Project: PRA-ROCR 10(5)
The purpose of this Amendment is to:

Amendment No. 0002
Project PRA-ROCR 10(5)
Rock Creek Park
Solicitation: DTFH71-16-R-00001

Project Name: Beach Drive from Rock Creek Parkway to Maryland State Line

AMENDMENT NO. 2 ◇1	PMIS NO.	NPS NO.	STATE	PROJECT	SHEET NO.
	044965	821 / 100425	DC	PRA-ROCR 10(5)	D37

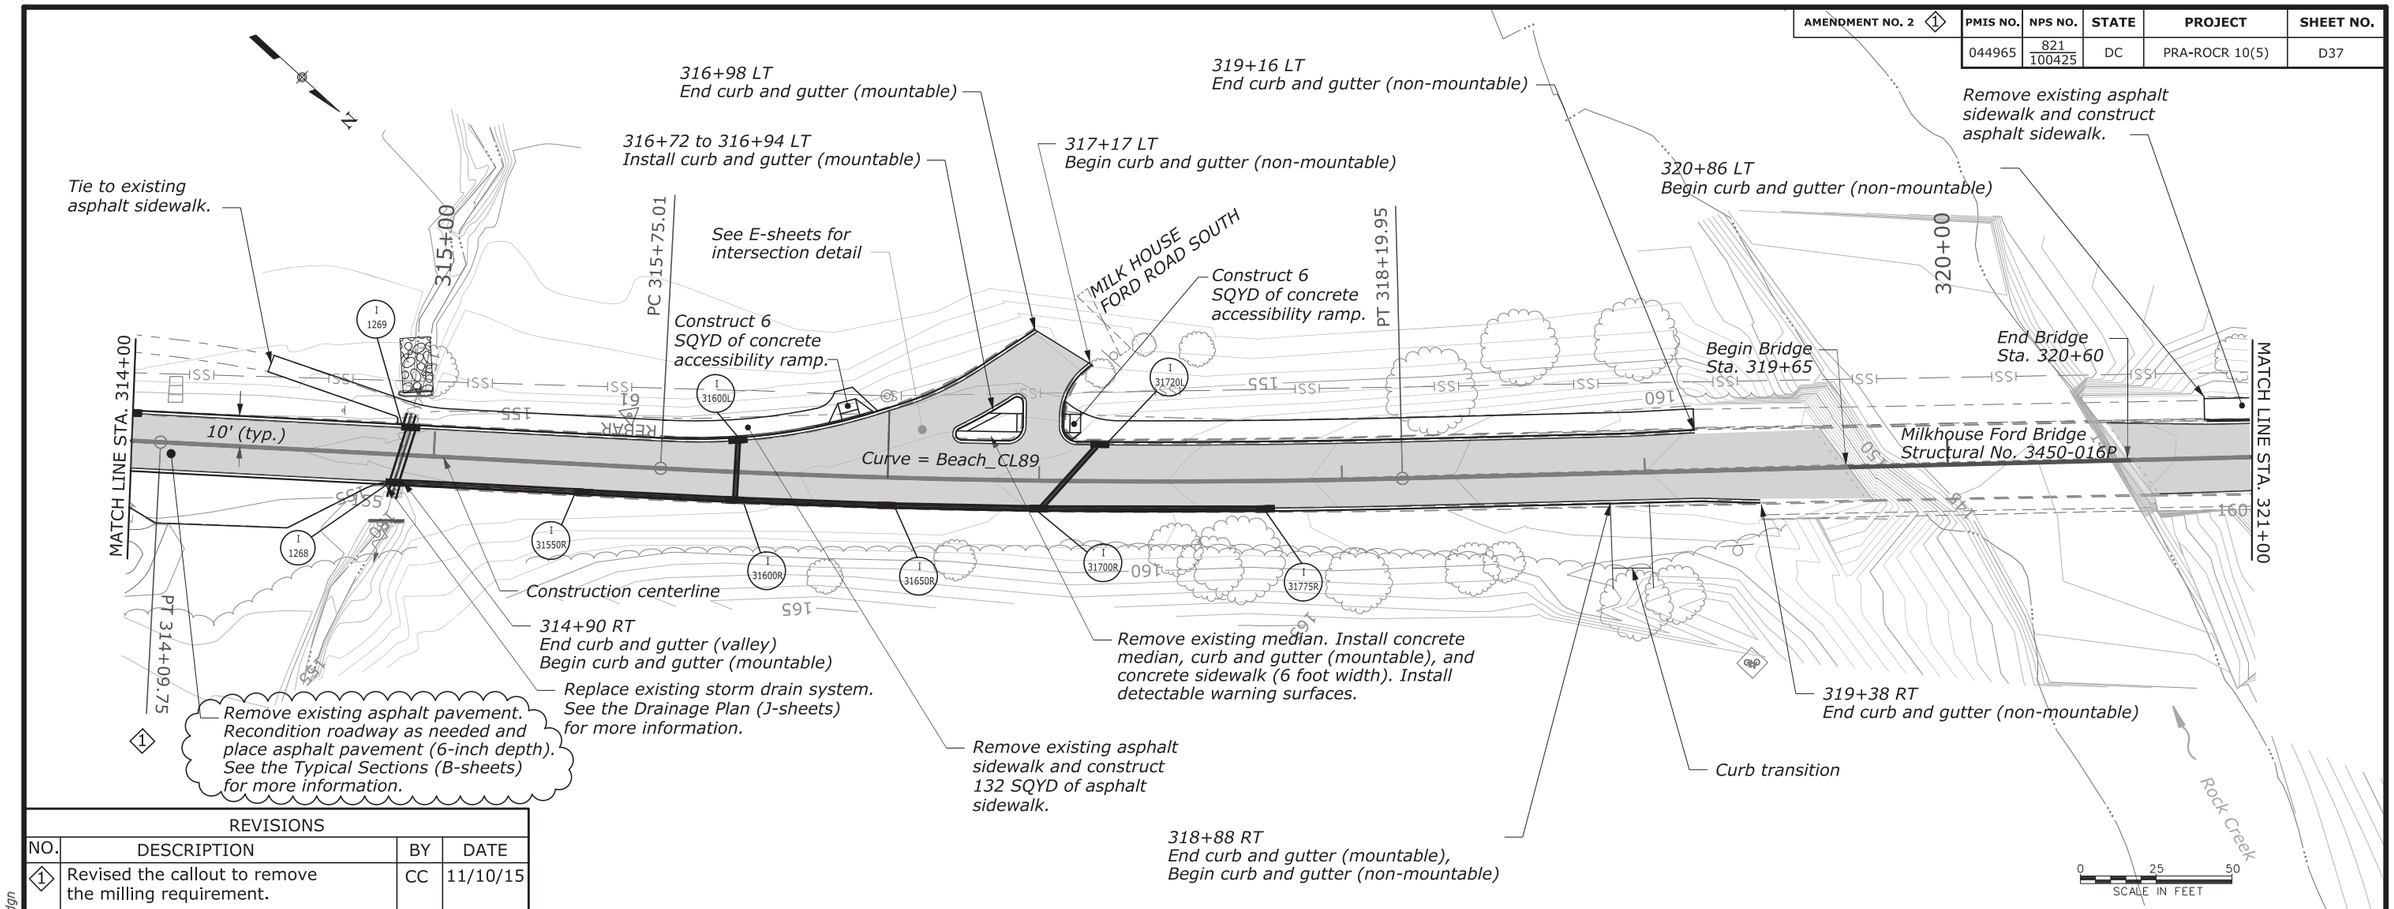
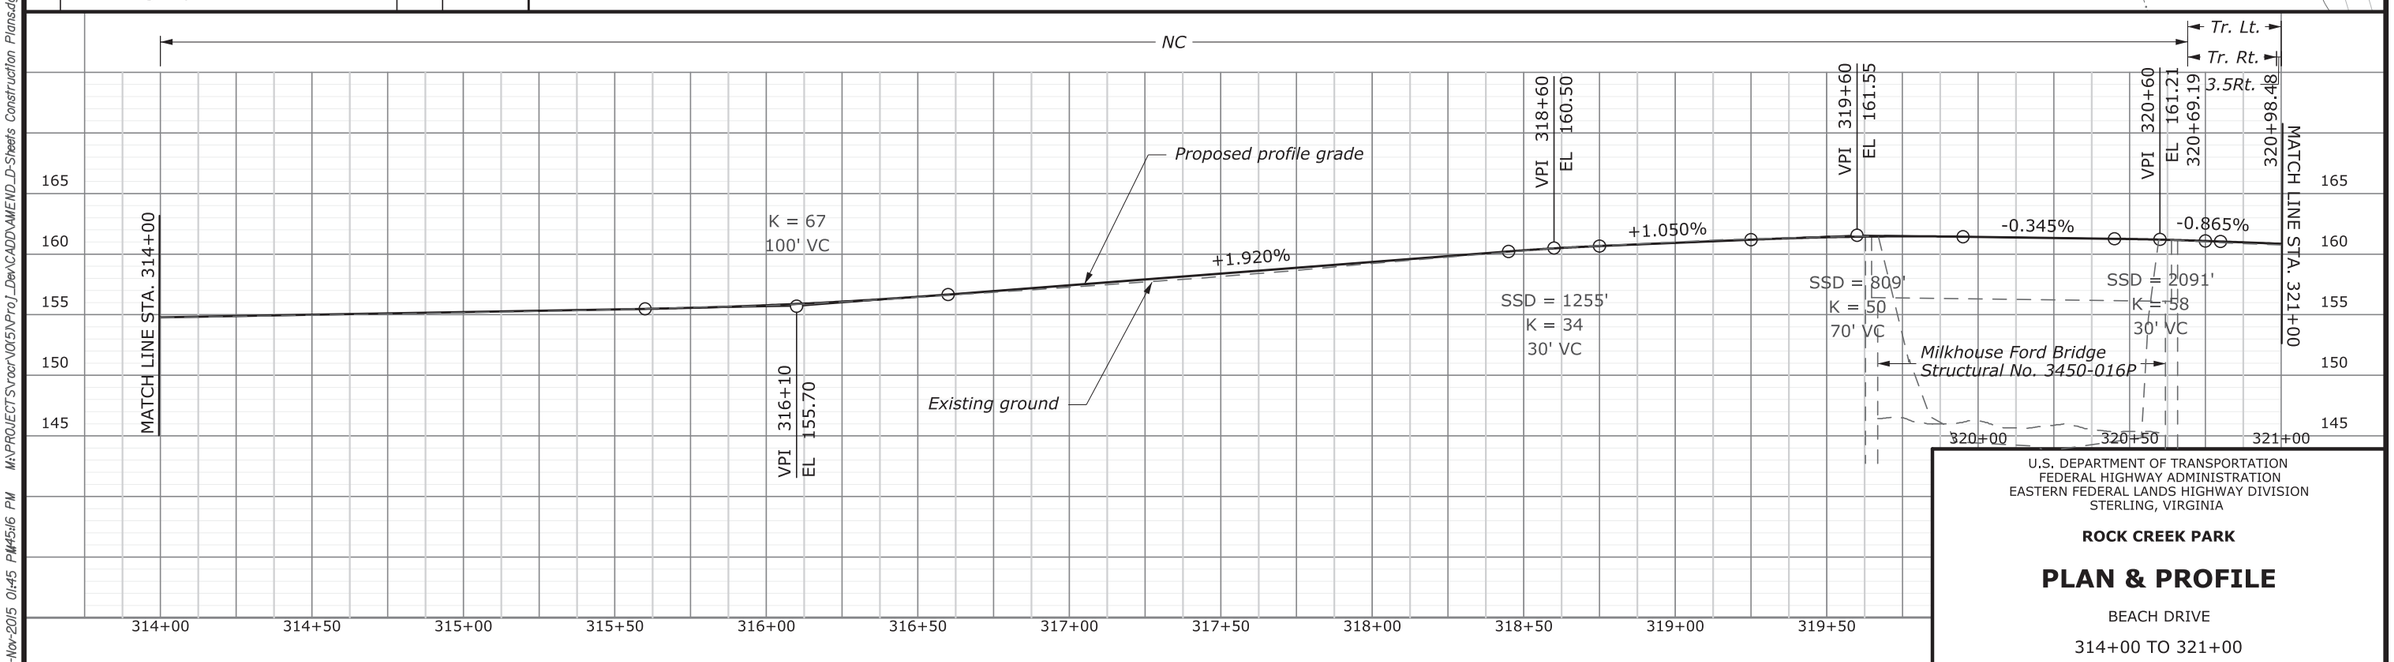
REVISIONS			
NO.	DESCRIPTION	BY	DATE
◇1	Revised the callout to remove the milling requirement.	CC	11/10/15

AMENDMENT NO. 2 ◇1	PMIS NO.	NPS NO.	STATE	PROJECT	SHEET NO.
	044965	821 / 100425	DC	PRA-ROCR 10(5)	D38

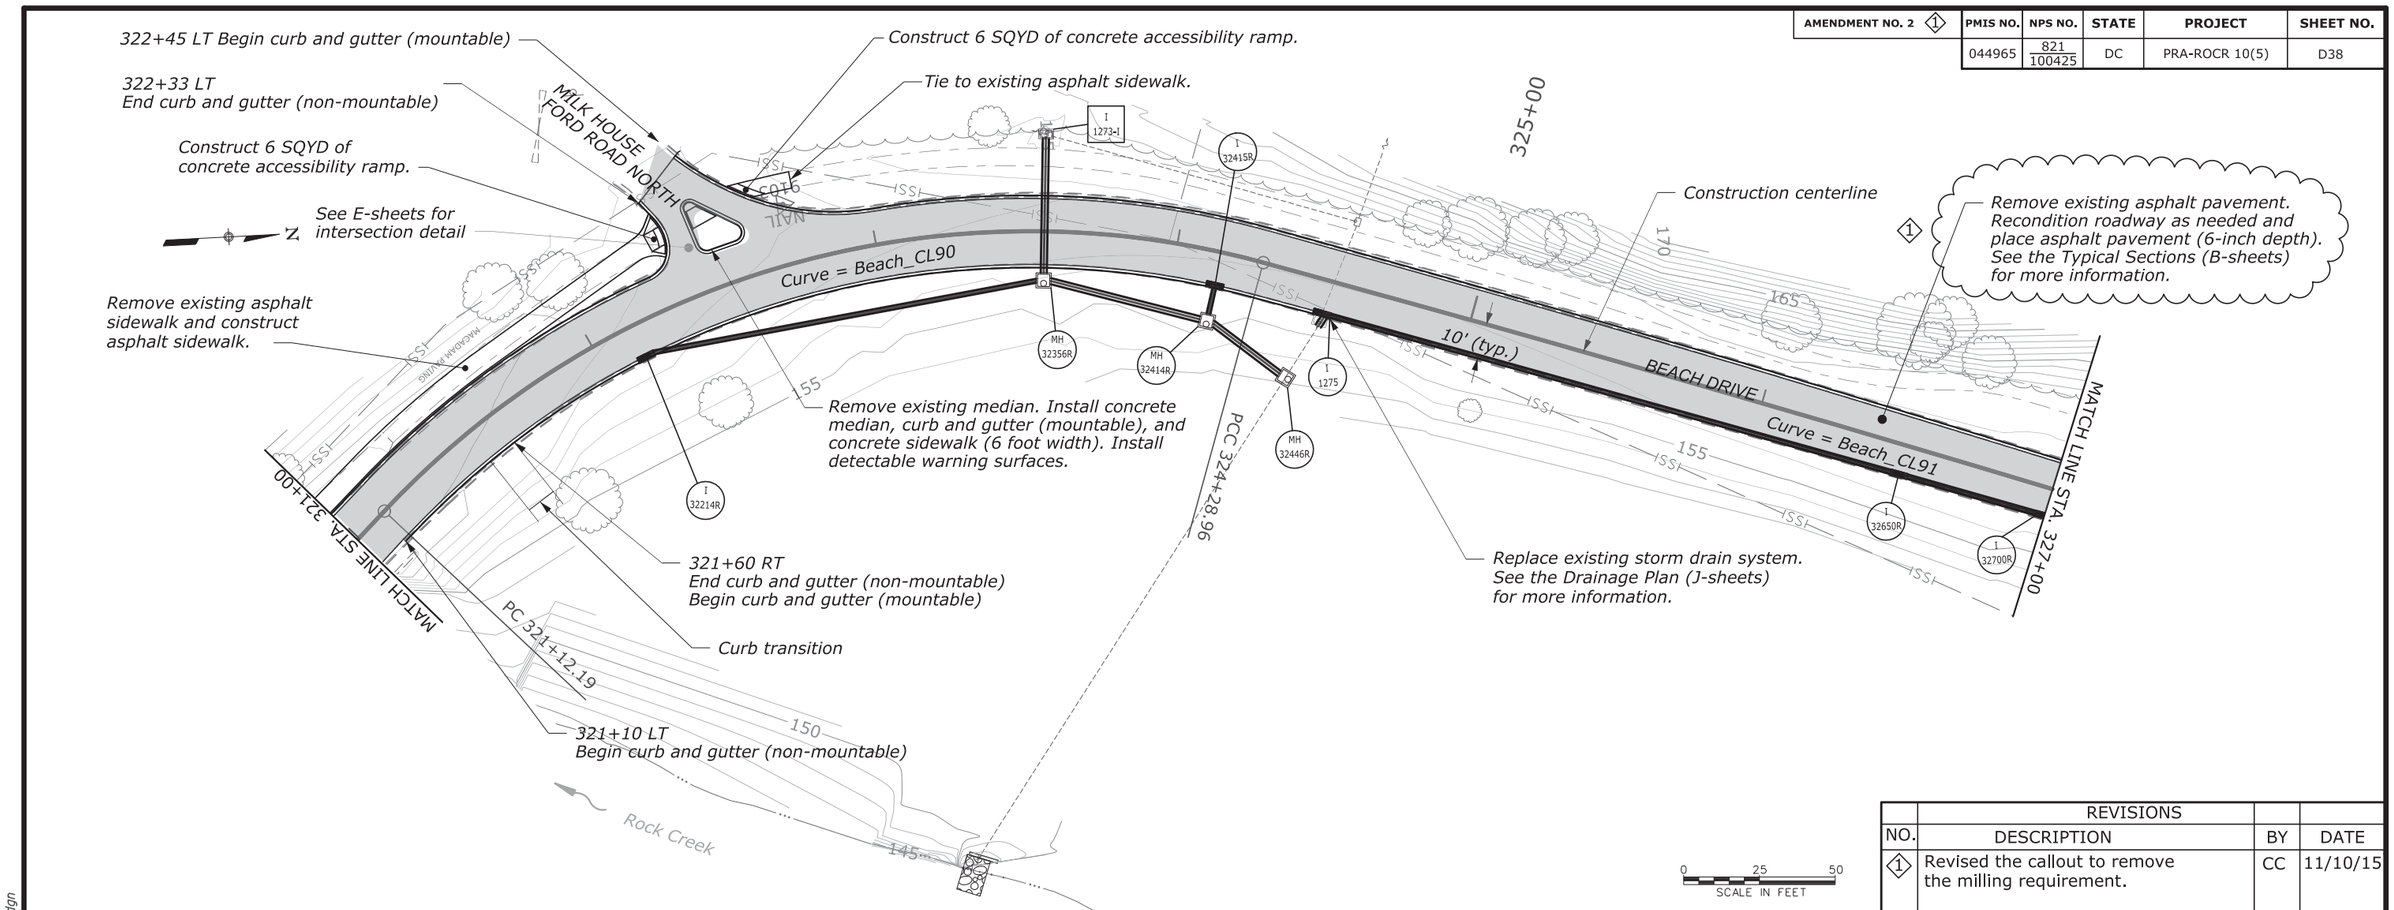
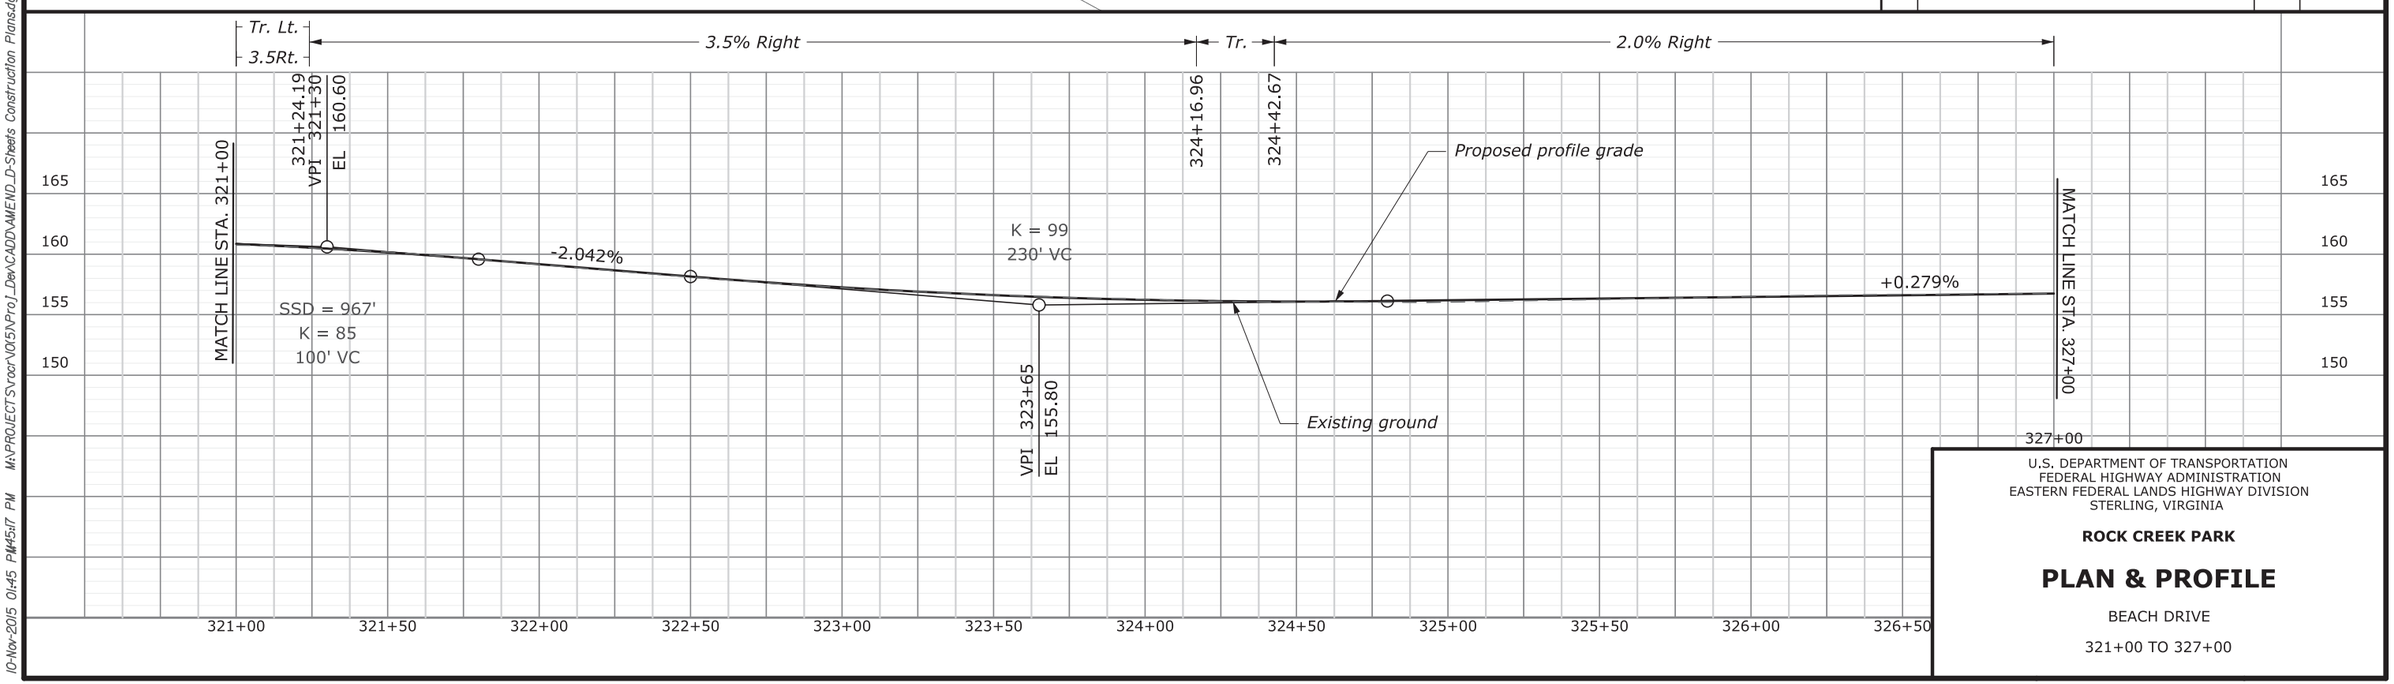
REVISIONS			
NO.	DESCRIPTION	BY	DATE
◇1	Revised the callout to remove the milling requirement.	CC	11/10/15

AMENDMENT NO. 2 ①	PMIS NO.	NPS NO.	STATE	PROJECT	SHEET NO.
	044965	821 / 100425	DC	PRA-ROCR 10(5)	D39

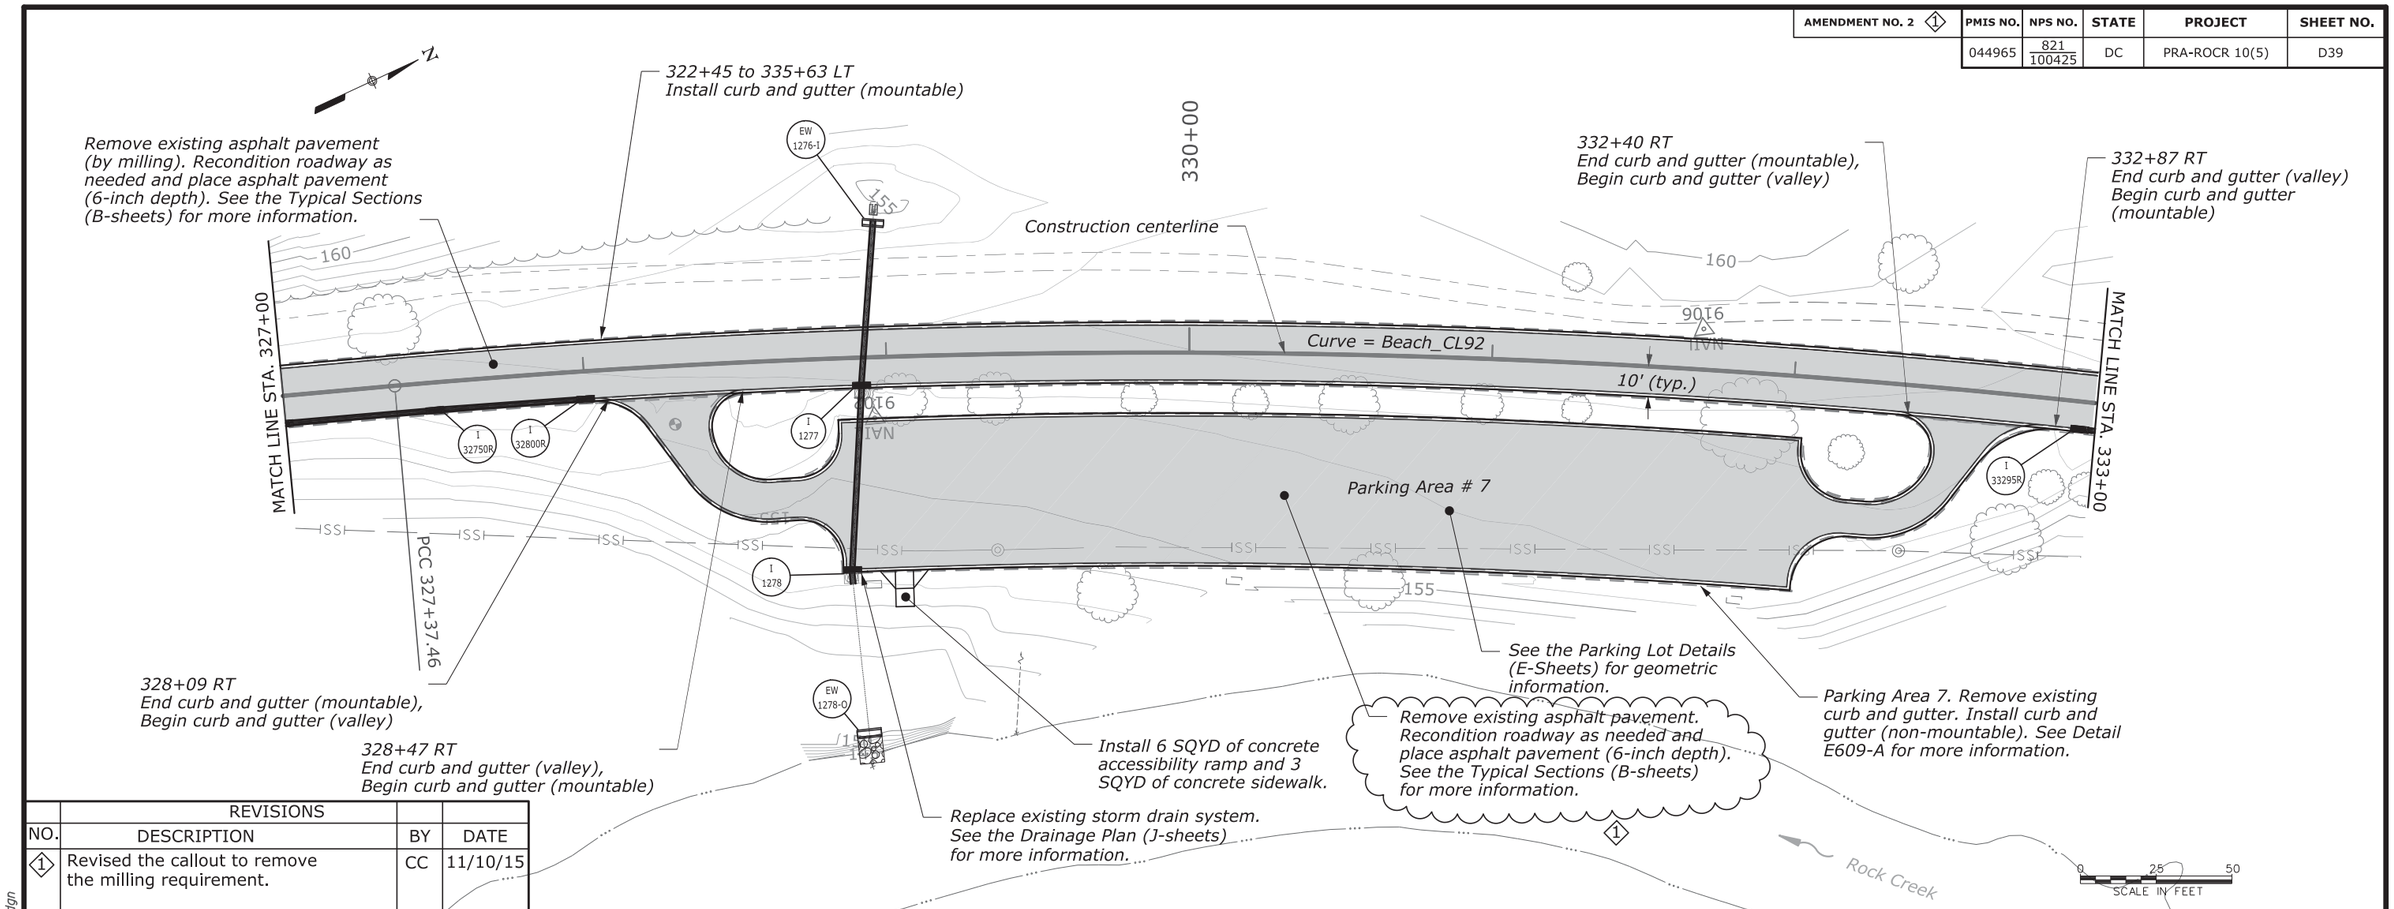
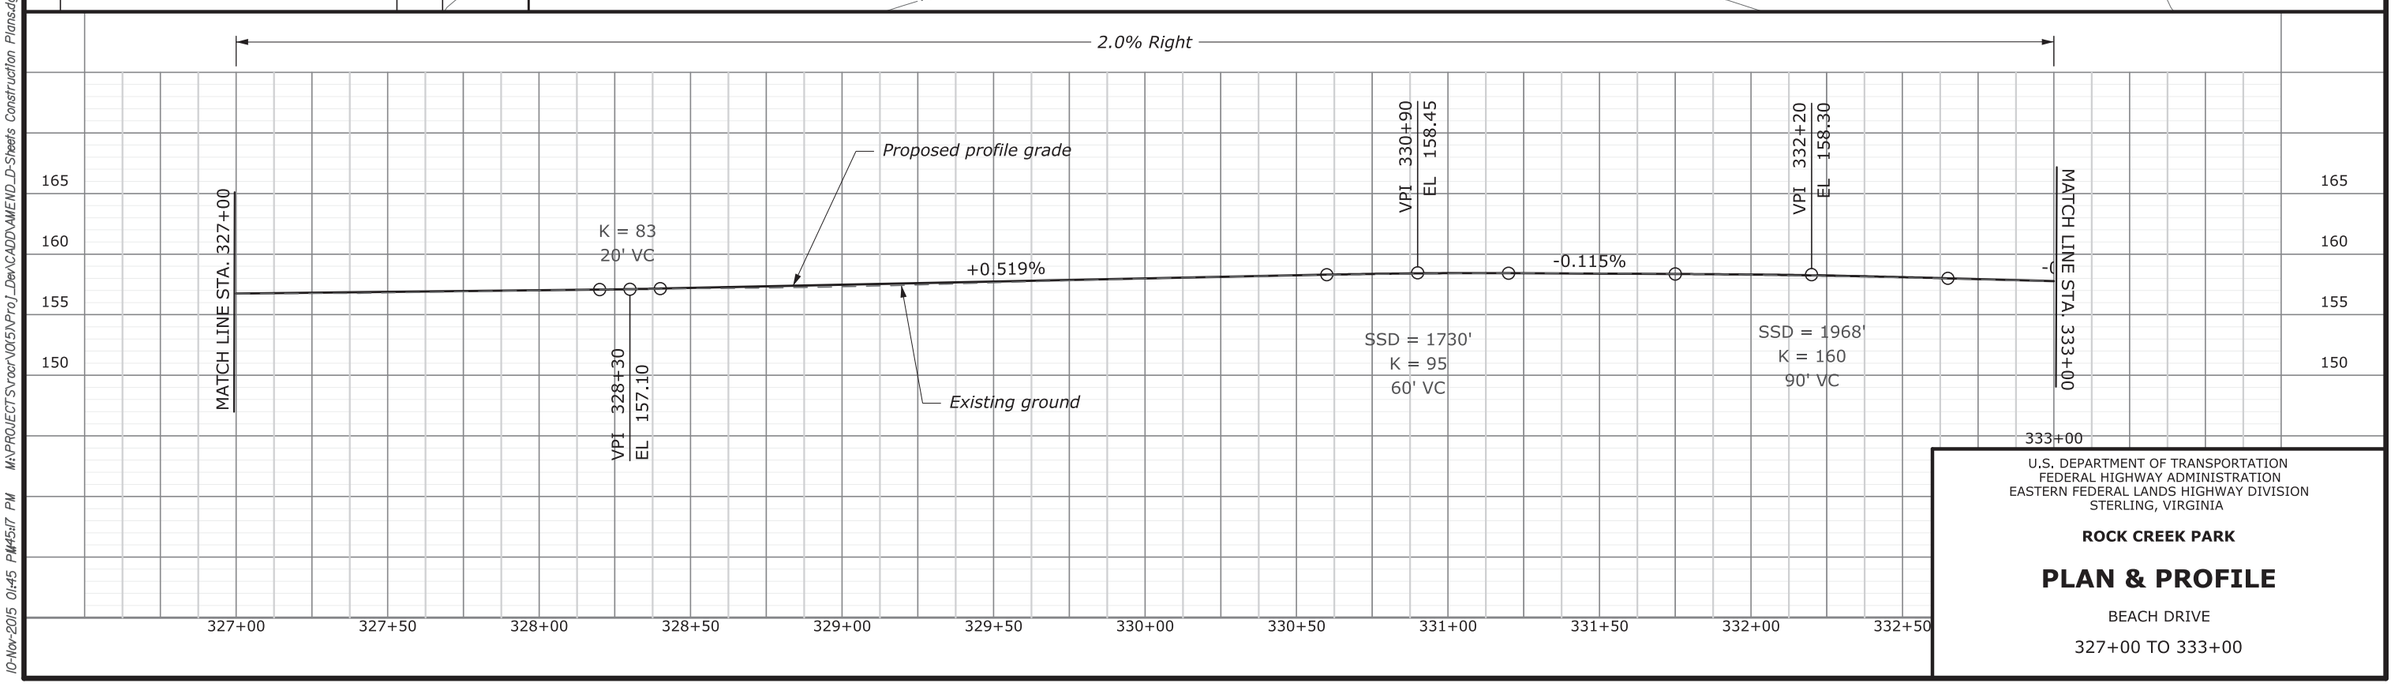
REVISIONS			
NO.	DESCRIPTION	BY	DATE
①	Revised the callout to remove the milling requirement.	CC	11/10/15
